Subject: Additional Information Regarding IE Bulletin 85-03

RESPONSE TO NRC REQUEST FOR ADDITIONAL INFORMATION (RAI)
REGARDING IE BULLETIN 85-03

UPDATE TO FERMI 2 IE BULLETIN 85-03 RESPONSE PROGRAM
DELETION OF E5150F059, RCIC MOV X

IDENTITY LIST FOR 3" TOP MECH. THROTTLE TRIP VALVE	SCHUETTE & ROBERTING CO. MANUFACTURING ENGINEERS CORNWELLS HEIGHTS DUCKS COUNTY, PA
12-9-69 PARTS LIST 69-XC-113	69-S-2/1

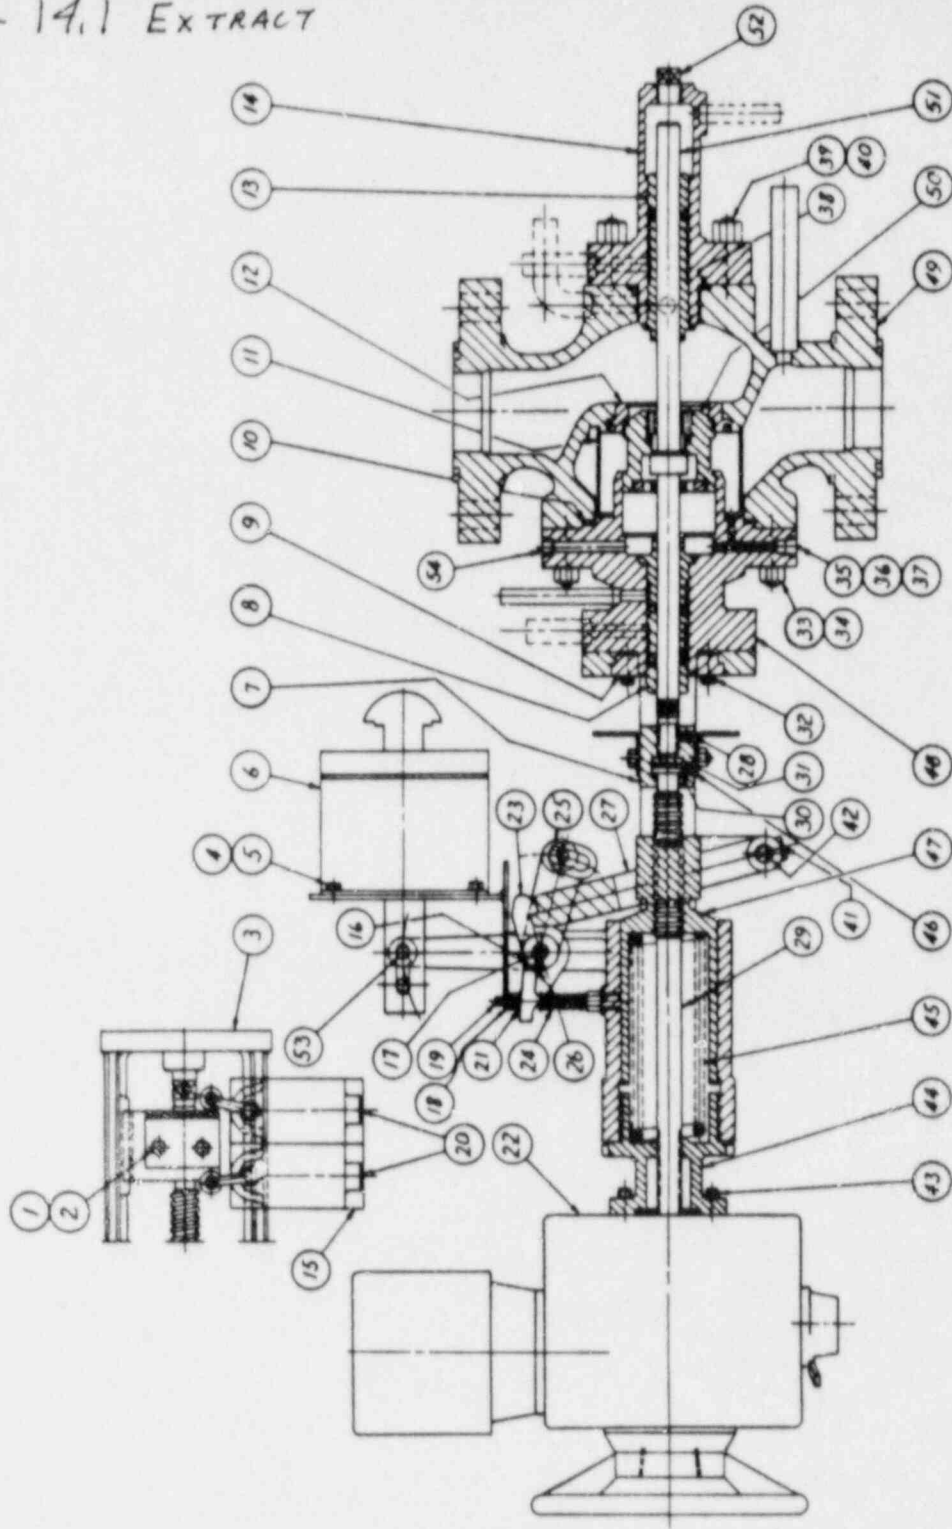
MOV E5150F059 will be deleted from the Fermi 2 long-term response program for IE Bulletin 85-03. The BWROG report, NEDC-31322, Table 4, notes that this valve has an active safety action to close. This closure is on a turbine overspeed trip which is effected by a mechanical latching and spring closure subassembly. Section 3.3.4.15 of NEDC-31322 states this MOV was included "for the purpose of completeness" because it was in the ASME XI program of some plants. Likewise, Fermi 2 has tested this MOV during Outage 88-01 for completeness of the initial test program. This valve, however, is not part of Fermi 2's ASME Section XI ISI program for pumps and valves.

E5150F059 is a Shutte & Koerting Company, 3" X 4" Top Mechanical Throttle and Trip Valve. The valve was originally supplied as part of the RCIC turbine assembly. An extract of the relatching operation is attached. The Limitorque motorized actuator serves two functions for the operation of the valve. First, it is primarily used for the relatching and valve resetting function. The screw spindle is a fixed, hollow shaft with internal and external threads. The internal threading drives the valve stem; external threads are driven by the actuator. This stem is non-rising and cannot be used to calibrate thrust-to-spring pack displacement, as required for the MOVATS 2150 Test System.

On turbine trip, the E5150F059 closure spring provides a downward impulse to the valve stem. The flow-over-disk configuration assures closure and tight seating. The upstream MOV, E5150F045 (MOV 1), RCIC Steam Admission Valve, closes subsequently to turbine trip. Steam pressure on both sides of E5150F059 is vented to the barometric condenser. Relatching is a local-manual activity coordinated with the control room for actuator positioning. The maximum opening force experienced by the actuator is that required to compress the trip-closure spring.

In summary, E5150F059 closes on spring force and upstream pressure. It opens during valve manual-relatching/reopening only against the trip closure spring force. RCIC operation, particularly startup or trip, is independent of the E5150F059 motor-operated capacity for opening or closing the valve. Therefore, this valve does not meet the criteria for inclusion in the IE Bulletin 85-03 response program and will be deleted from the program. No further programmatic testing will be performed on E5150F059 for the IE Bulletin 85-03 long-term response.
